Access Compliance Report

Public Rights-of-Way

| Intersection ID: 43887 | Main Street: DOGGETT_ST | Cross Street: ABBOTT_ST | Location: NW |
| ADA ID: 021374BDBB6C | Ramp Type: PerpDiag | Initial Pass/Fail: Fail | Overall Compliance: No |

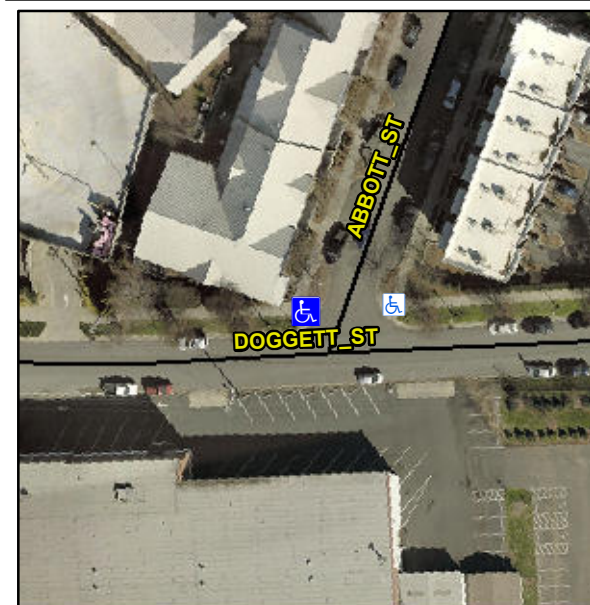
R304.5.3

| Compliance | Description | Data | Compliance | Description | Data |
|------------|-----------------------|------|------------|-----------------------------|------|
| Yes | Ramp Width (in) | 70.0 | No | Ramp XSlope (%) | 9.7 |

Remove & Replace Curb Ramp With Two New Directional Ramps or Equivalent.
